Enclosed please find a copy of the Environmental Evaluation Group's latest report, Review of the WIPP Draft Application to Show Compliance with EPA Transuranic Waste Disposal Standards, March 1996 (EEG-61).

REVIEW OF THE WIPP DRAFT APPLICATION TO SHOW COMPLIANCE WITH EPA TRANSURANIC WASTE DISPOSAL STANDARDS

March 1996

EEG-61
DOE/AL/58309-61

Figure 1. Oil and natural gas resource categories. After Broadhead et al., 1995.[2-17]

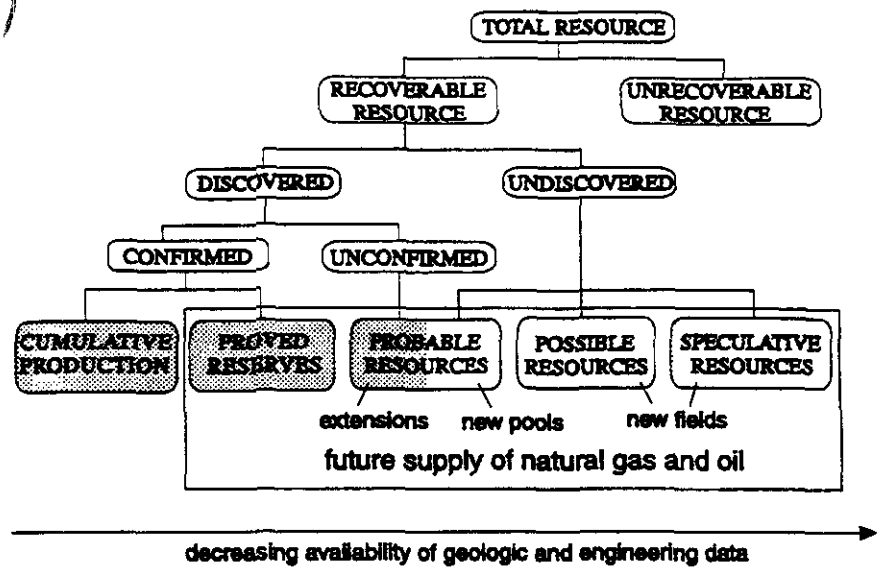
The definitions for the terms *proven reserves, probable reserves* and *possible reserves* are incorrect. The correct terms are proved reserves, probable resources, and possible resources (See Figure 1).

The DCCA definitions are given without reference and are inconsistent with the definitions used in Broadhead et al.[2-17], as discussed below.

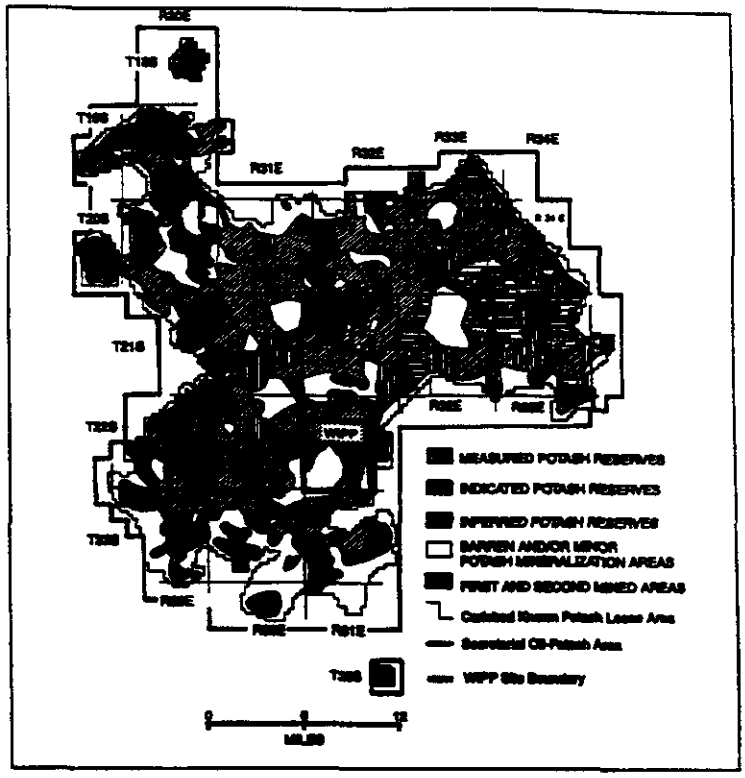
It appears that the quantities of potash summarized by this table are incorrect and do not reflect the higher quantities considered by the BLM to be reserves as a matter of official policy. The discussion would benefit from maps of the potash resources such as that prepared by Griswold and Broadhead et al.[2-17], and those prepared by Silva for the June 13, 1995, EEG Workshop on waterflooding as shown in Figures 2 and 3.

Figure 4. Oil, gas, and injection wells in nine-township project study area. Adapted from Broadhead et al.[2-17] by Matthew Silva (EEG).

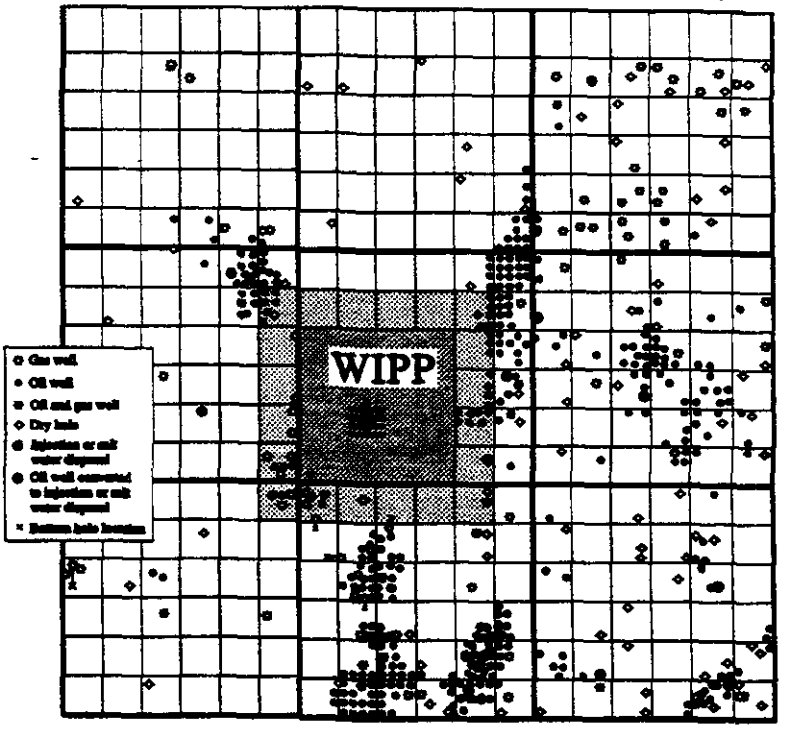
The section on hydrocarbon resources would benefit from a presentation of a map of current well locations and a map of existing oil and gas wells and applications for permit to drill as indicative of the interest of the oil and gas industry (Figures 4 and 5). The 1995 summary of previous evaluations by Broadhead et al.[2-17] is mentioned in this section but the 1994 summary and analysis by Silva[2-19] is not mentioned. Proper citation procedure dictates citing Silva[2-19]. It would also be worthwhile to provide a map of proven and probable reserves for the various formations such as those contained in Broadhead et al.[2-17].

Figure 6. Estimates of WIPP RH-TRU Inventory from 1980 to 1995.

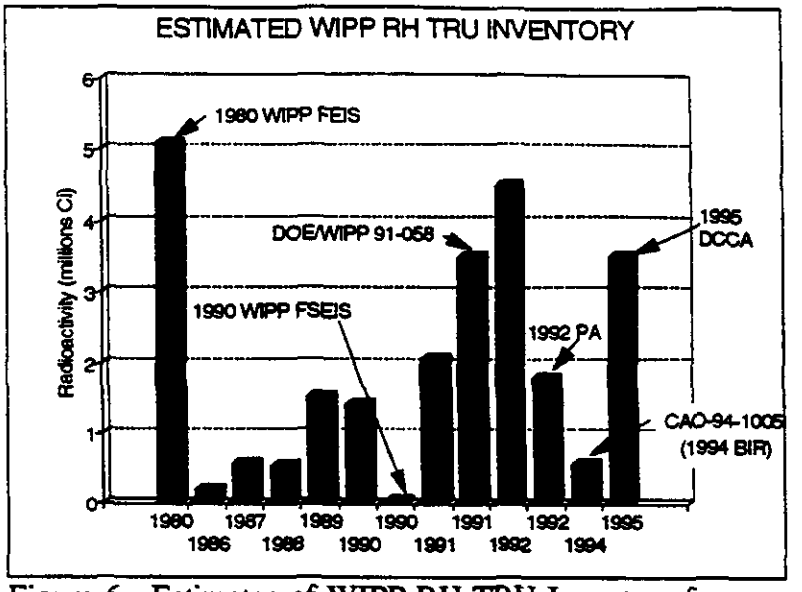
The DCCA suggests that the amount of RH-TRU is a small percentage of the WIPP TRU inventory. While this is true by volume, the RH-TRU waste is 37% of the total radioactive inventory according to the B.I.R. (Vol. III, page 4-11), and 33% of the total according to Volume I, page 4-15.

The inventory shown in Table 4-1 (page 4-4) does not agree with the inventory shown in Table 4-1 (page 4-5) of the Baseline Inventory Report published in Volume III, the supporting appendix (BIR). The RH-TRU projected inventory has varied widely over the years, as shown at the right[4-1] (Figure 6). DOE should make an effort to explain why the latest values are correct. Rev. 1 of the BIR increased the RH-TRU inventory by a factor of 3 to 4 and Rev. 2, December 1995 (received 2/9/96) increases the RH-TRU inventory by a factor of 5.6 over Rev. 1 to 27.000 m^3, considerably larger than the existing design capacity of 7080 m^3 for the RH-TRU.

Figure 7. Comparison of Cranwell and DCCA Elimination Criteria.

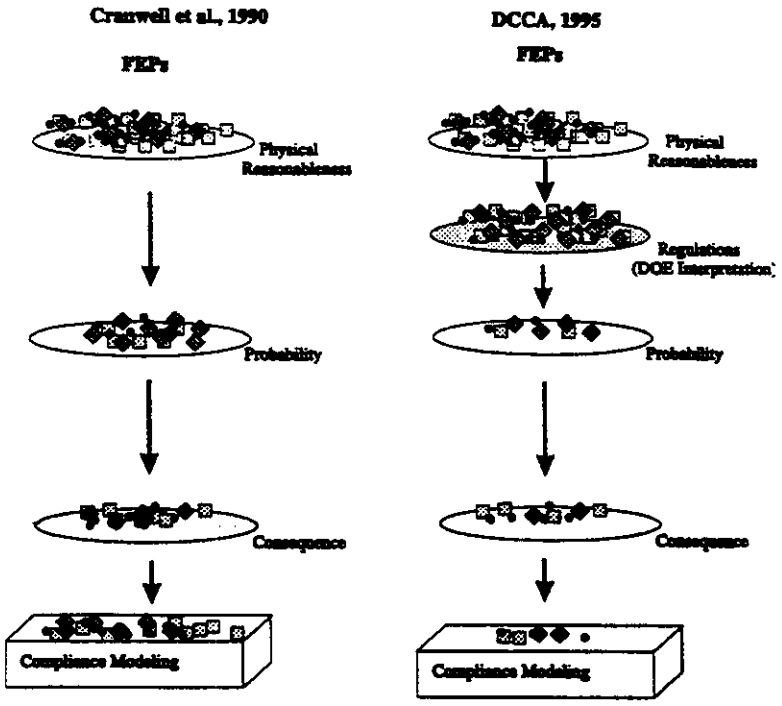
Interpretation) as shown in the figure below. Further, the procedure is such that the DOE determines which scenarios can be eliminated based on the DOE interpretation of the EPA regulations.

Delete as a criteria for elimination of FEPs the new category, "*Regulation or, more broadly, scope and purpose of the assessment...*" The category is entirely subjective as applied and ignores valid technical considerations.

Figure 8. Natural Resources around WIPP site.

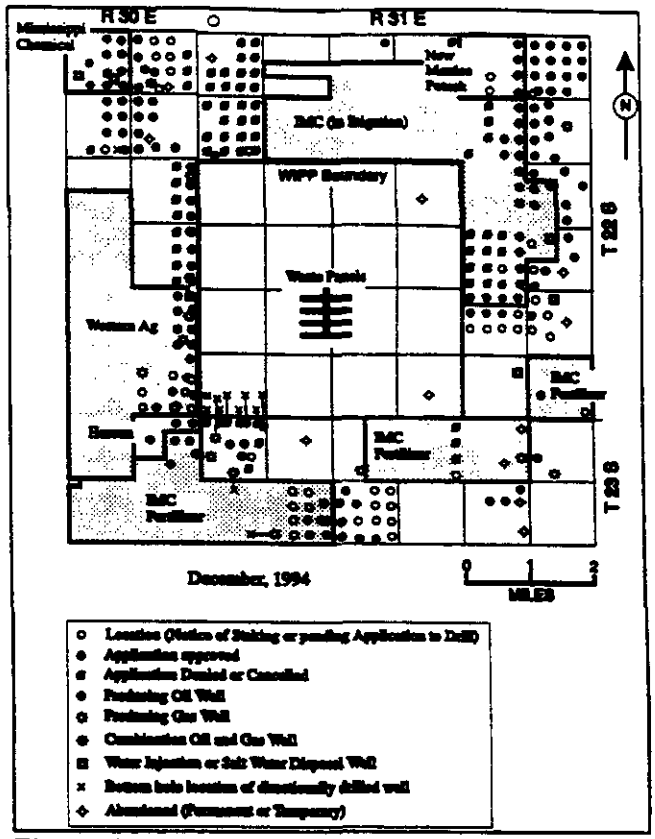
The WIPP is undeniably located in a resource rich area as shown in the Figure 8.

Figure 1

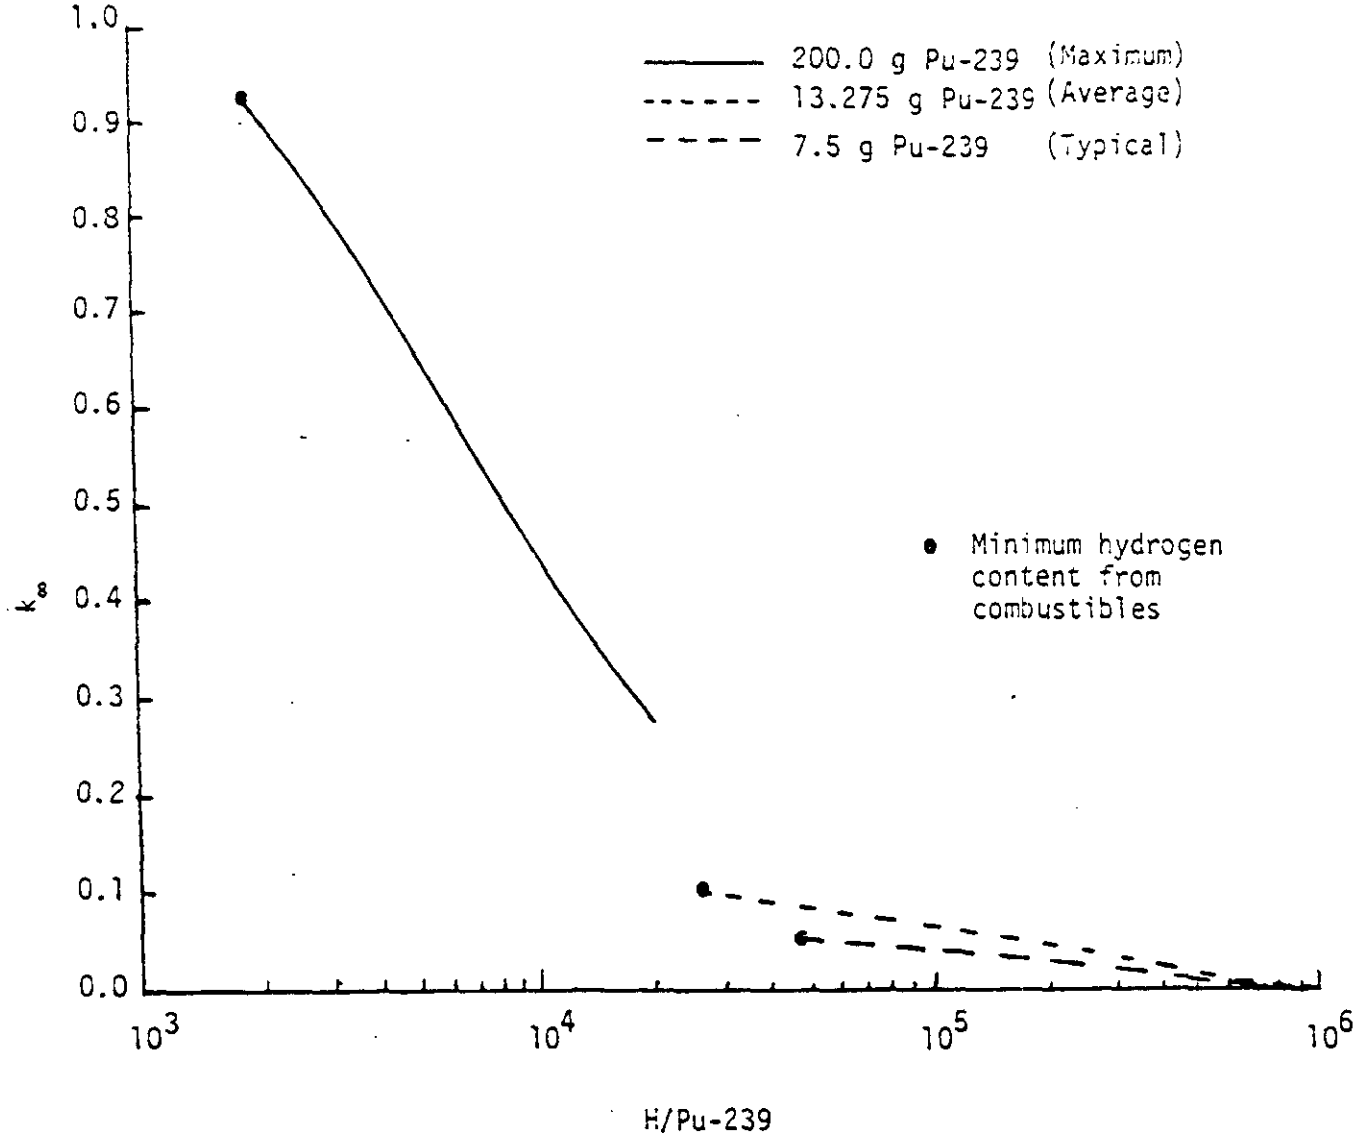
The results of the calculations, for the three drum loadings considered, are reproduced in Figure 1. The average drum loading was determined by assuming that 3% of the drums contain the maximum 200 gm plutonium, and the remainder contain the typical 7.5 gm. These k_∞ results are for an infinite array of drums, presumably modeled by using a reflecting boundary condition in cylindrical geometry.

(From Reference 9)

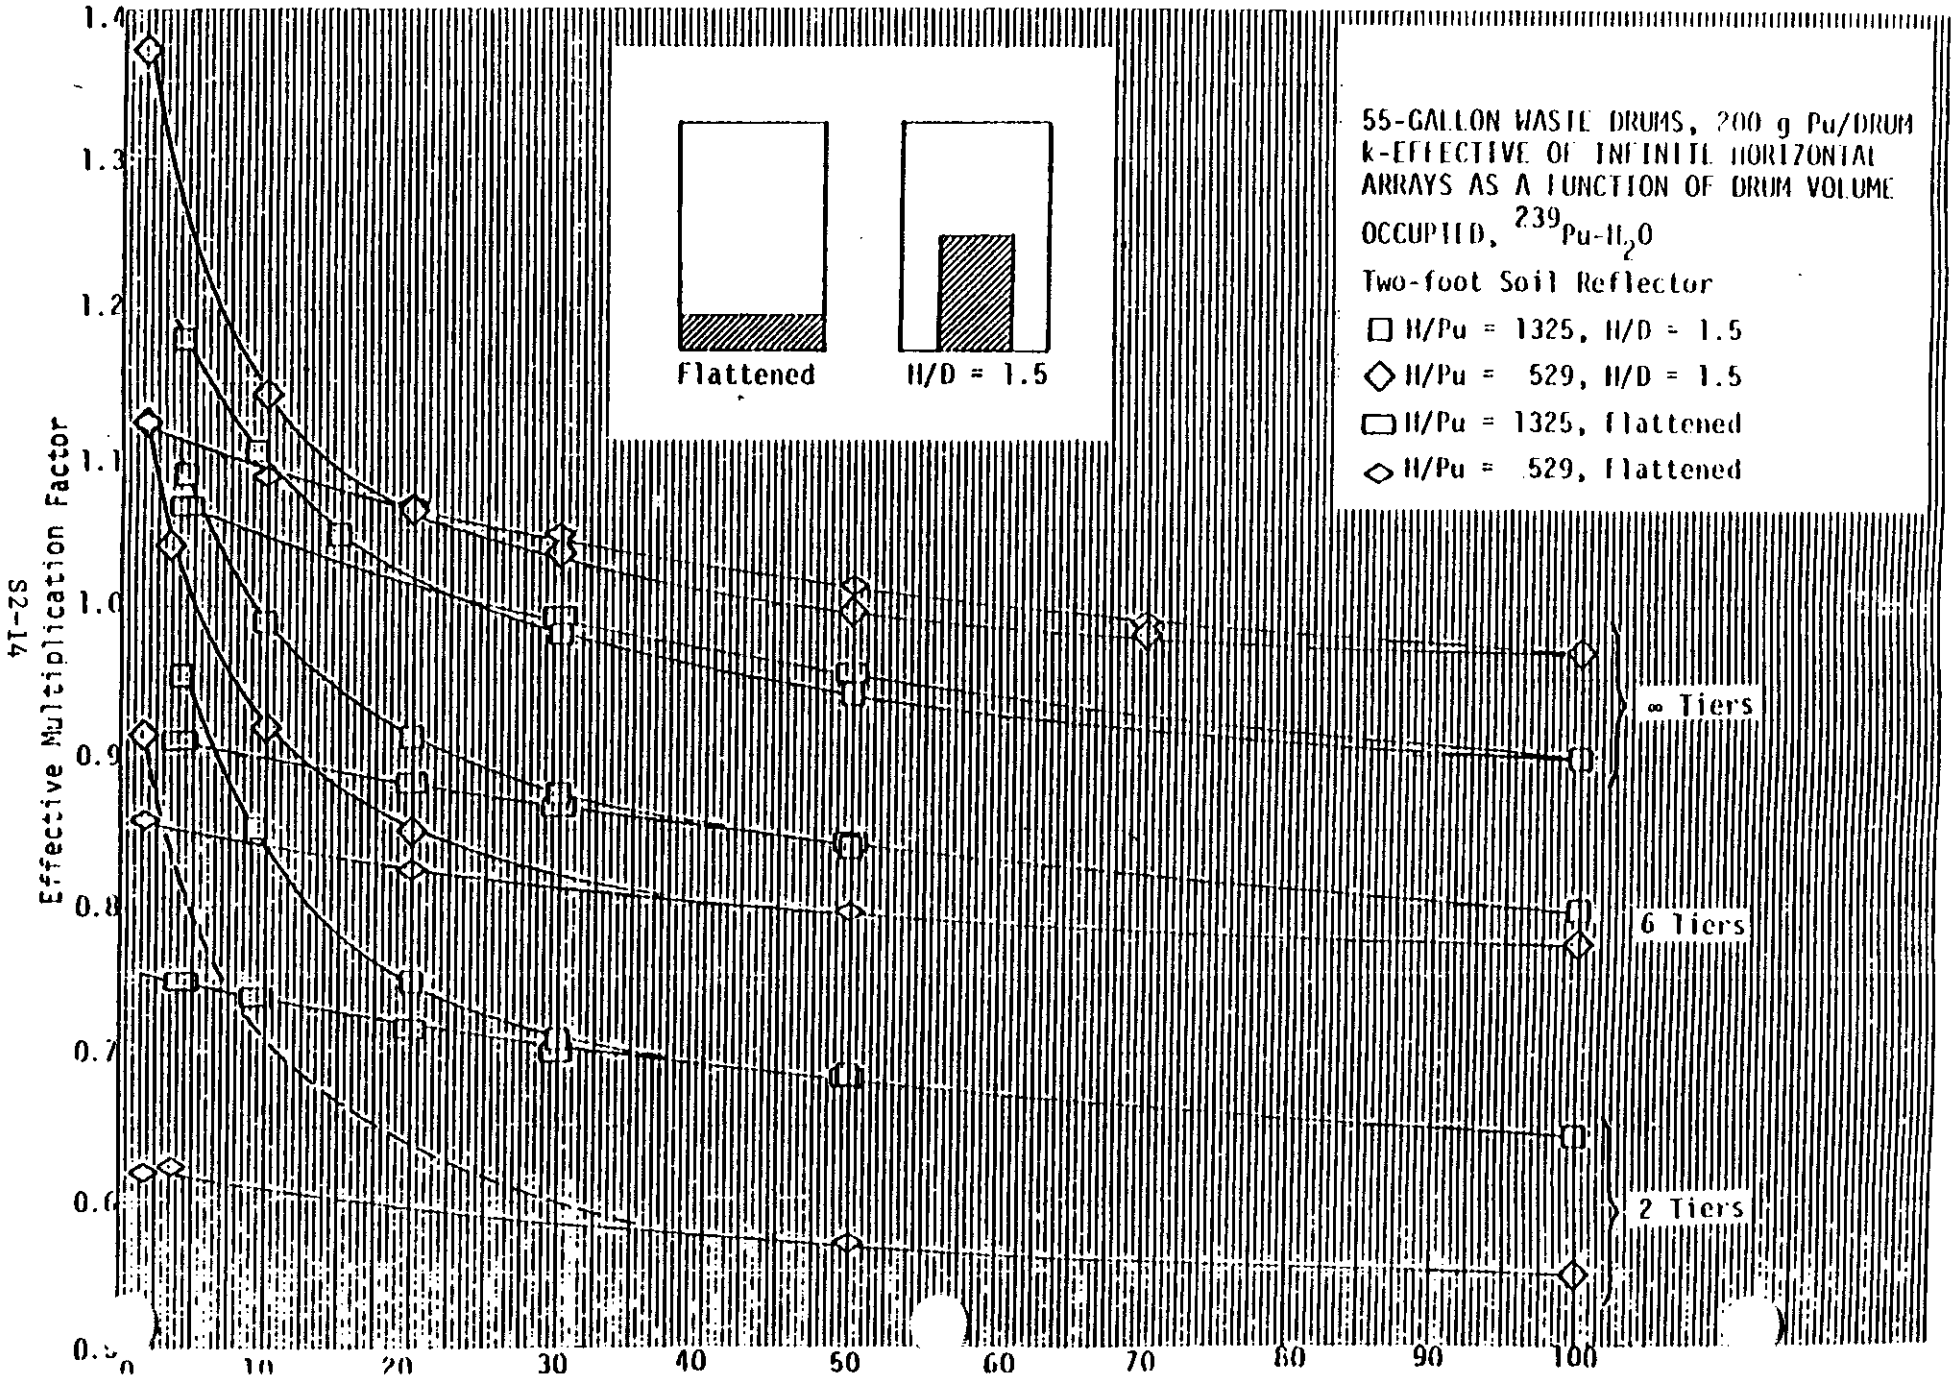
No attempt will be made to summarize all of the results here (approximately 200 separate calculations were performed). However, the most significant contribution of this work is the clear demonstration of the important effect that shape and density of the fissile material in the drum have on the results. The results demonstrate that modeling the plutonium-moderator mixture as uniformly distributed throughout the drum is <u>not a conservative assumption</u>. This is most clearly demonstrated in Figure 2, reproduced from Reference 9.

Figure 2 contains 3 sets of curves--corresponding to three heights of the array--an infinite number of tiers, 6 tiers, and 2 tiers. Each set of curves is displayed for two hydrogen to plutonium ratios, 1325 and 529. (Note that for the finite number of tiers, the higher H/Pu leads to higher k_{eff} values; this direction is reversed for the infinite number of tiers.) For any one of the curves, the point at the right (100% of drum volume occupied by fissile material) corresponds to the Pu^{239} - H_2O mixture smeared uniformly over the entire drum volume. As we move to the left, the mixture is compressed, either by flattening (denoted by ▭ and ⬭) or by "scrunching" into a cylinder with H/D = 1.5 (denoted by □ and ◇). The mode of volume reduction does not appear to affect the results down to roughly 35-40% reduction in volume for the 2 and 6 tier calculations. At this point the H/D = 1.5 results depart significantly from the flattening results.*
